FIRE SAFETY INSPECTION REPORT

UNITED COSTUME (PVT) LTD.

ACCORD
on Fire and Building Safety in Bangladesh

May 31, 2014

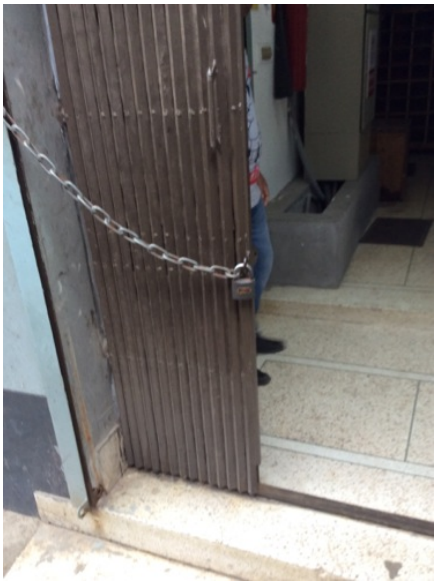
F-5	Fire Rated Construction	The exit stairs are not separated from work areas, other space on each floor by fire-rated construction. Location: All floors.	Provide minimum 1.5-hr fire rated doors and seal all unprotected openings to separate the exit stairs from work areas and other building spaces on all floor levels. Ensure that the fire doors are self-closing and positive latching and that they are provided with fire exit (panic) hardware where serving production floors. If fire doors are required to be held open for functional reasons, provide automatic-closing devices tied to the fire alarm system.	Within 3 months

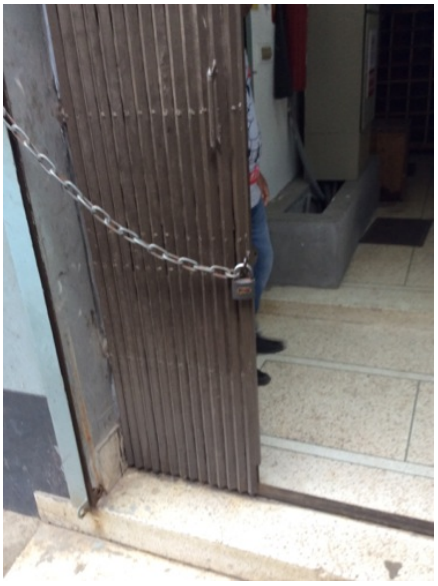
F-6	Egress	Egress doors / gates with locking features are provided at building exits, exit stairs, along egress routes, exit discharge. Location: On all floors and at exit discharges. All gates/doors were open and unlocked during the inspection.	Remove locking features from all egress doors / gates. If locks are required for security reasons, utilize special door locking features complying with NFPA 101.	Immediate

F-7	Egress	Storage was located in all the exit stairs.	Remove all storage from exit stairs and egress paths.	Immediate
